**REFL33 modification by KA Aug. 1, 2011**

Title <b>LSC Photodiode</b>		Date Last Modified: 17-May-99	
LIGO Laboratory California Institute of Technology Massachusetts Institute of Technology			
Size: B	DCC Number: D980454-01-C	PCB / SCH Revision: B / 1	Engineer: J. Suina D. Ouimette
File: S:\SYSTEMS\LSCPHOTOD-1\FINAL\SCHEMA-1\8045401A.SCH		Date: 12-Aug-1999	Time: 16:56:25
		Sheet 2 of 2

REFL33 (2011/8/3)

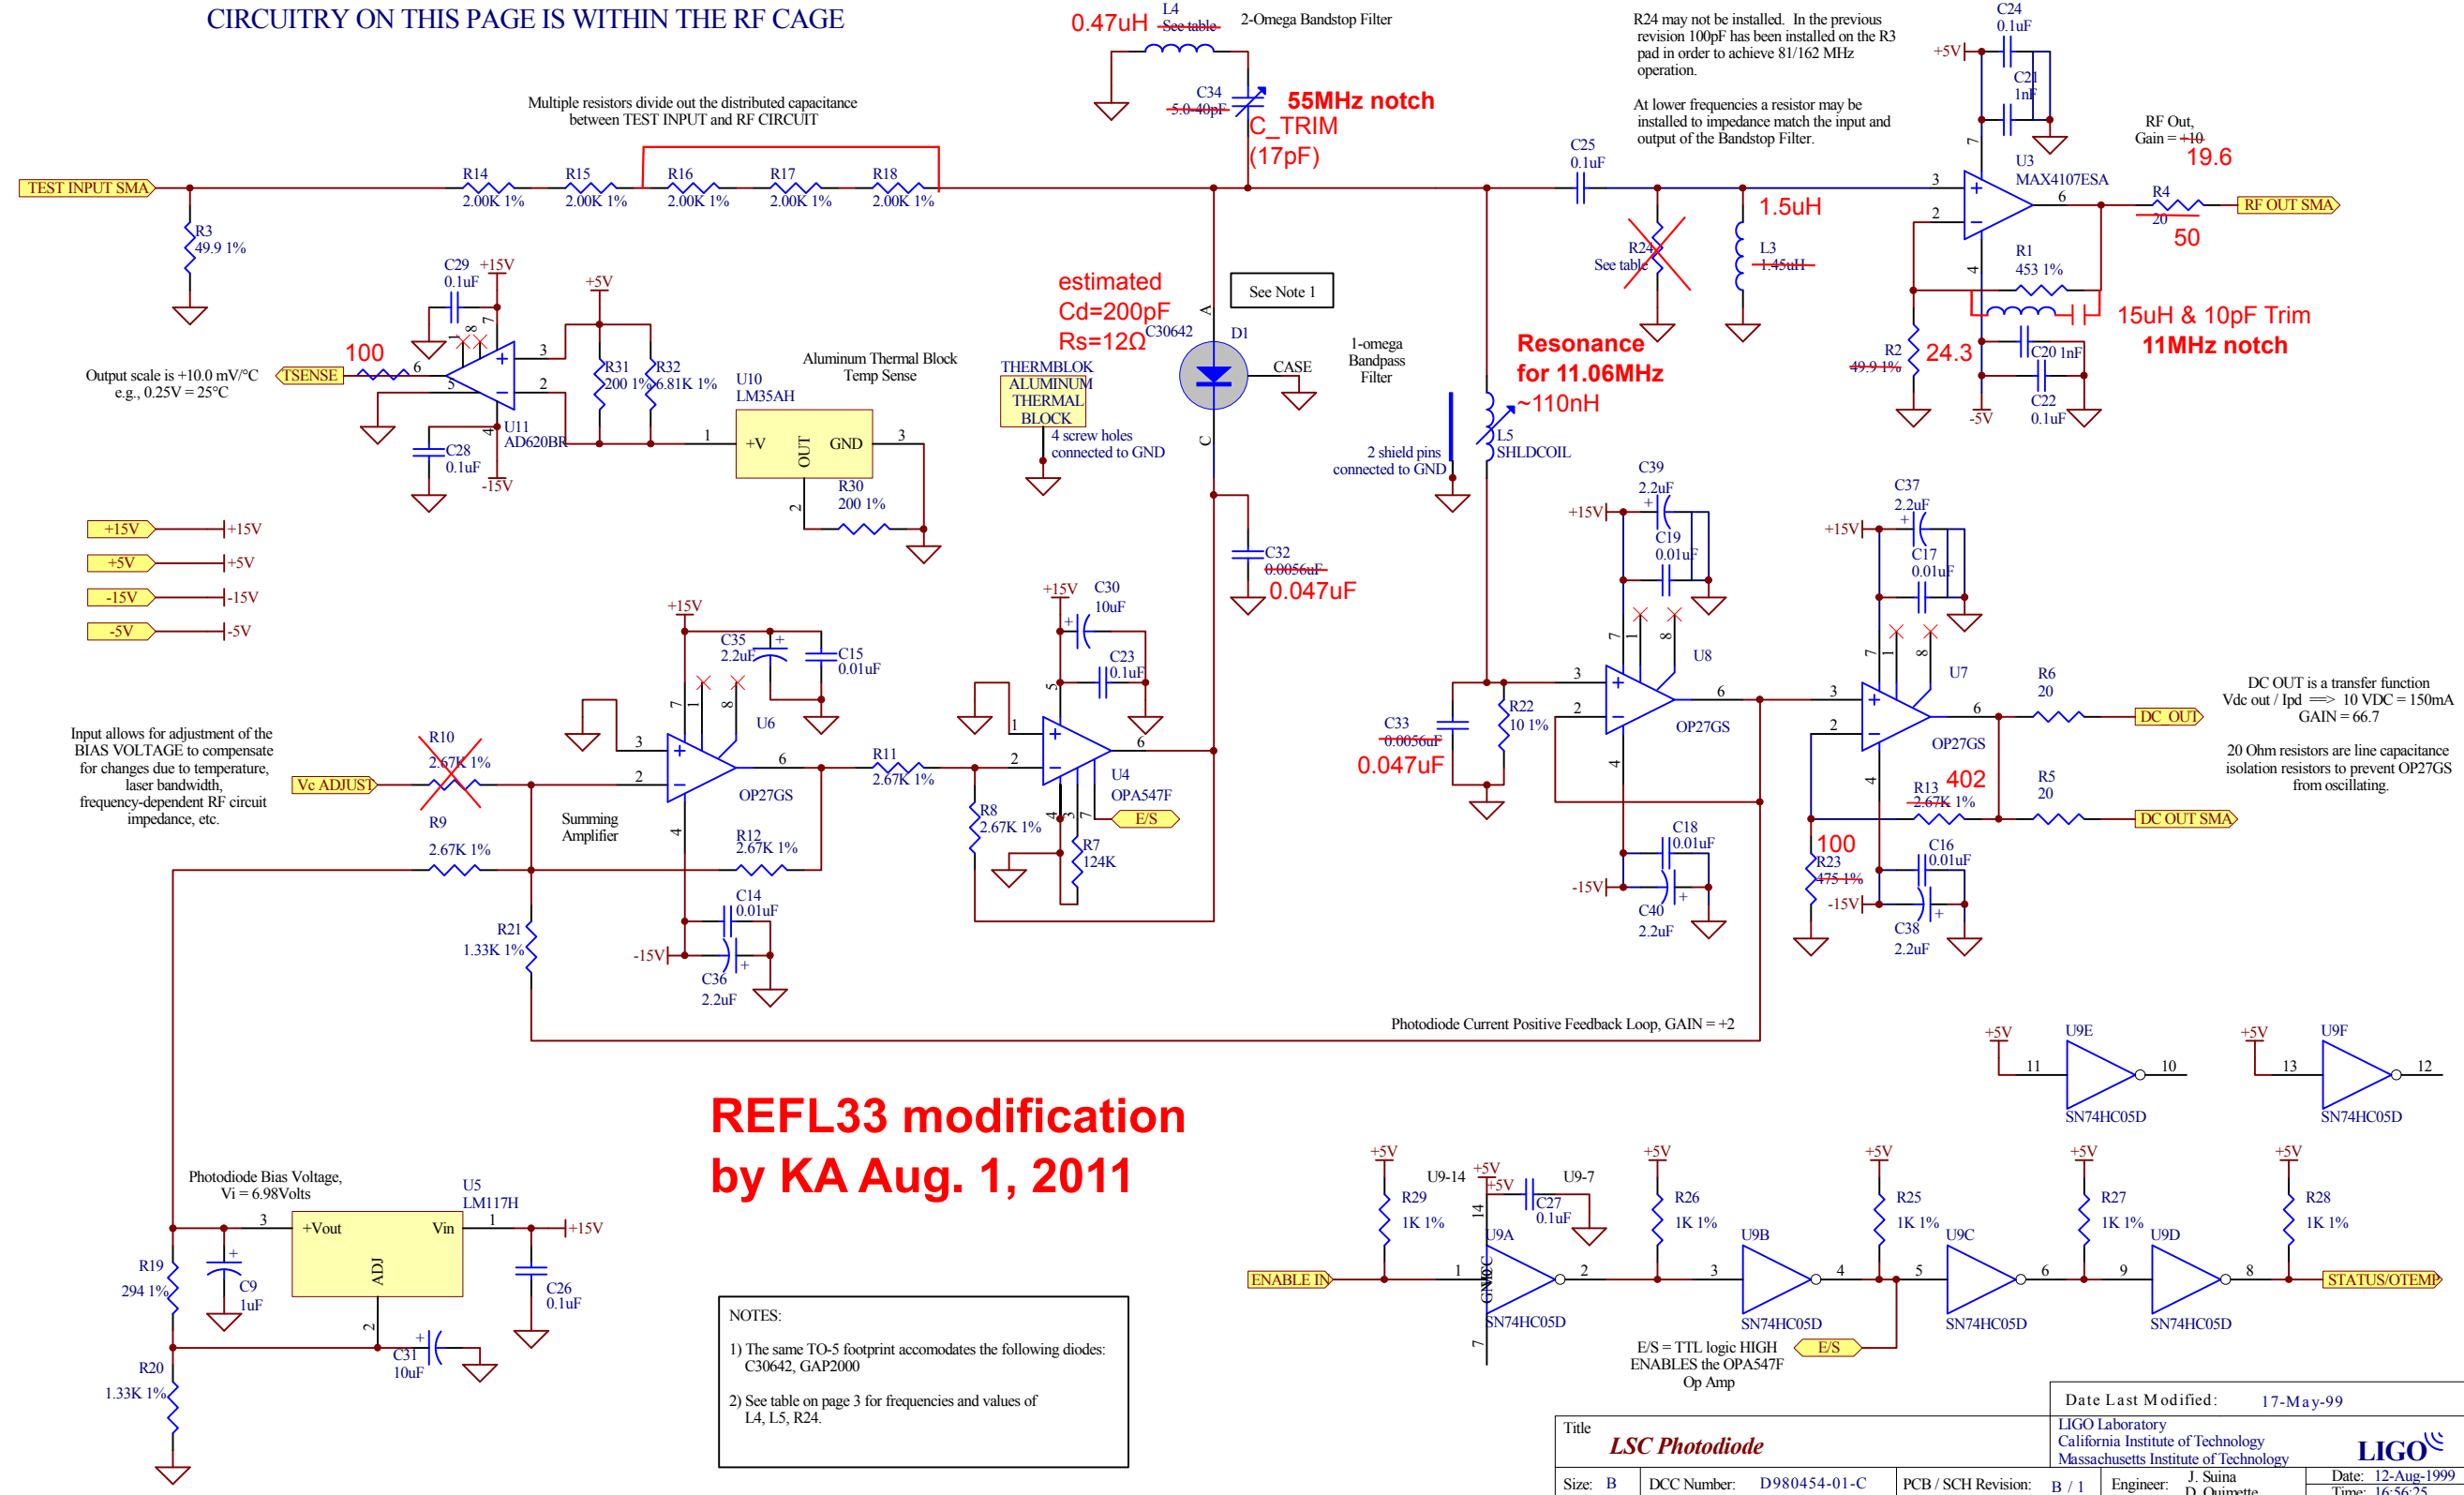
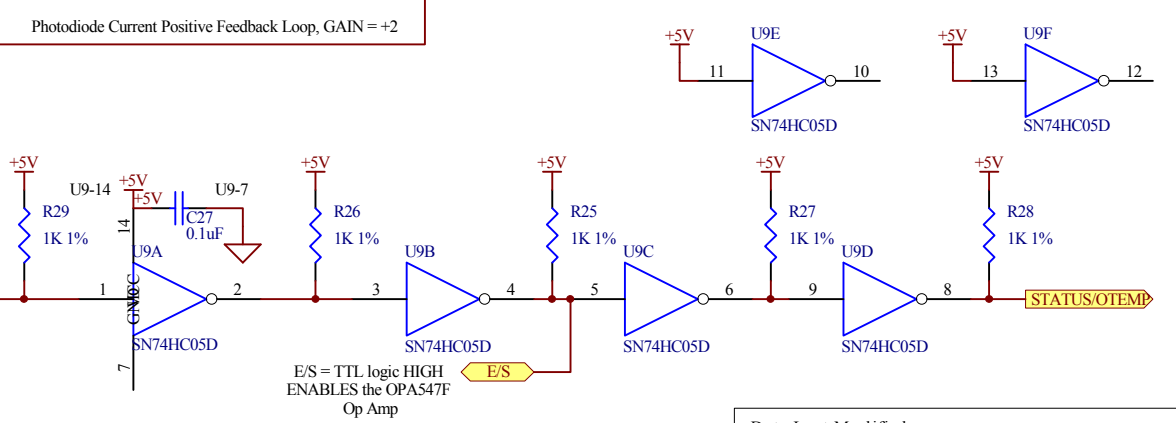
R24 may not be installed. In the previous revision 100pF has been installed on the R3 pad in order to achieve 81/162 MHz operation.  
At lower frequencies a resistor may be installed to impedance match the input and output of the Bandstop Filter.

Resonance for 11.06MHz ~110nH

15uH & 10pF Trim  
11MHz notch
